**ARCHITECTURAL REVIEW BOARD
MUNICIPAL PLANNING COMMISSION
-AGENDA-
Thursday, October 26, 2023 at 7:00 P.M.**

MEMORANDUM

SUBJECT: Staff Memo for the Meeting of October 26, 2023

PHOTOMETRIC PLAN

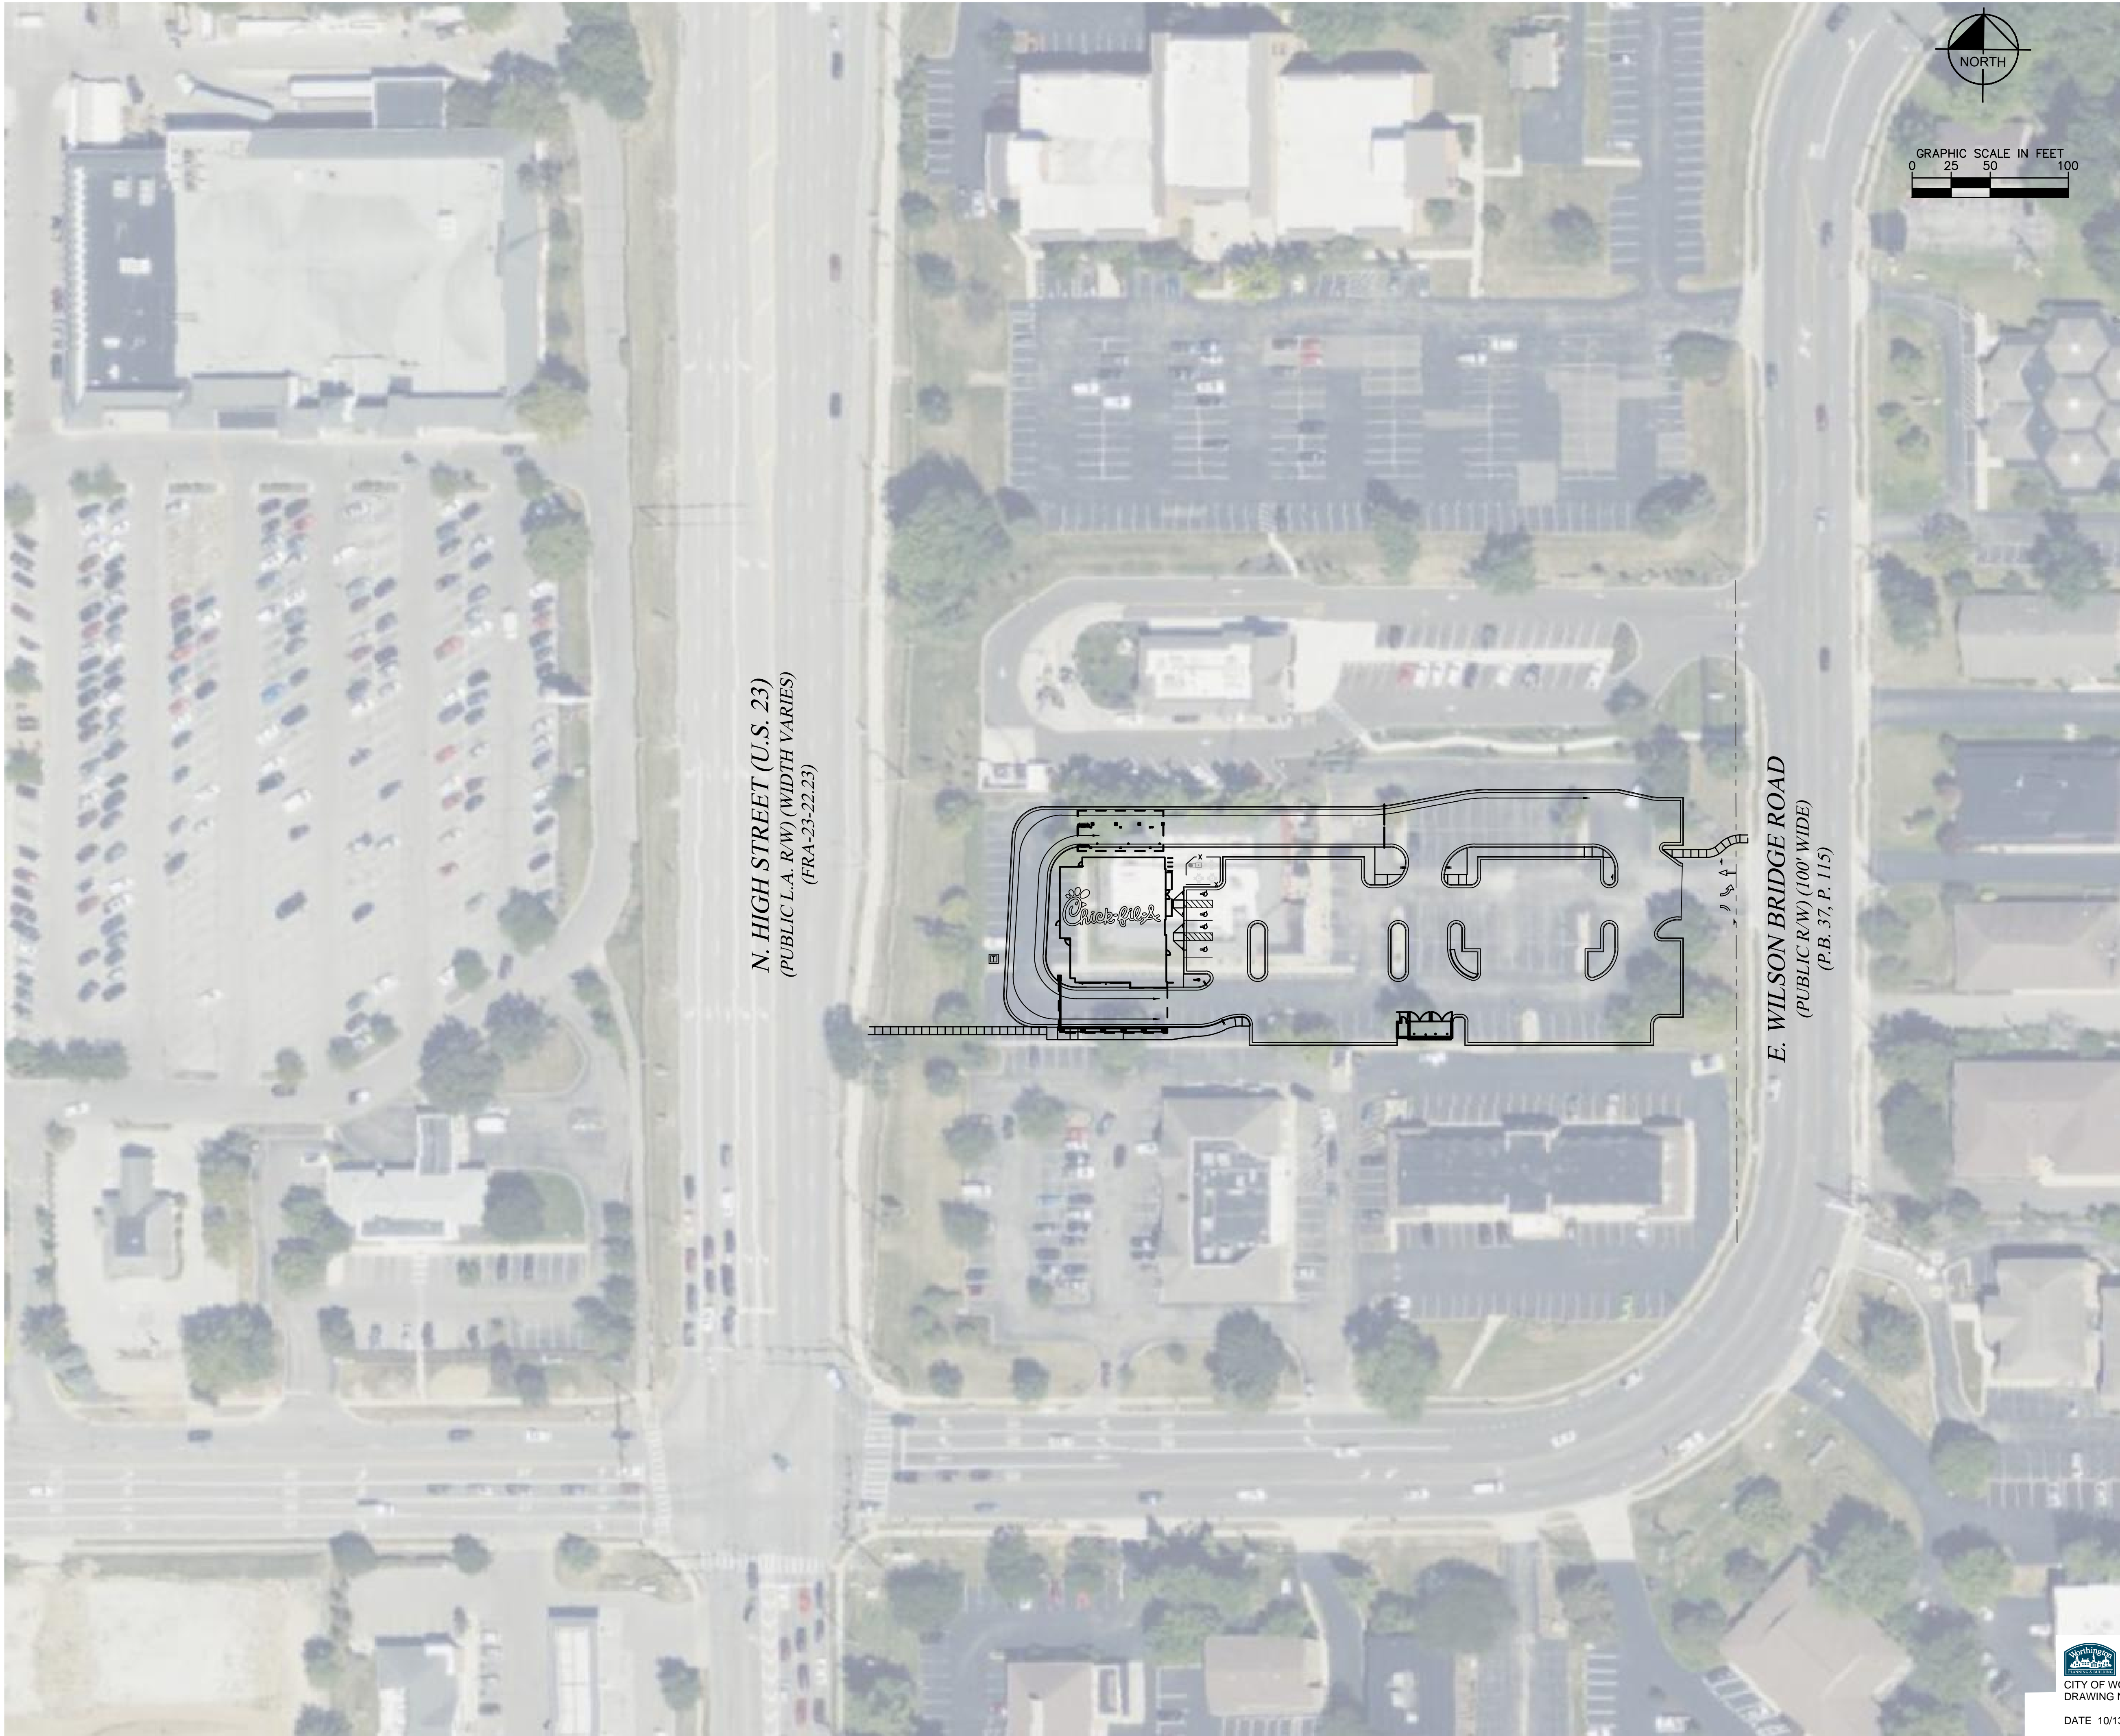
- The photometric drawing shows the average footcandles for the site would be 3.1. The brightest lighting level is under the canopies at 34.7 footcandles.
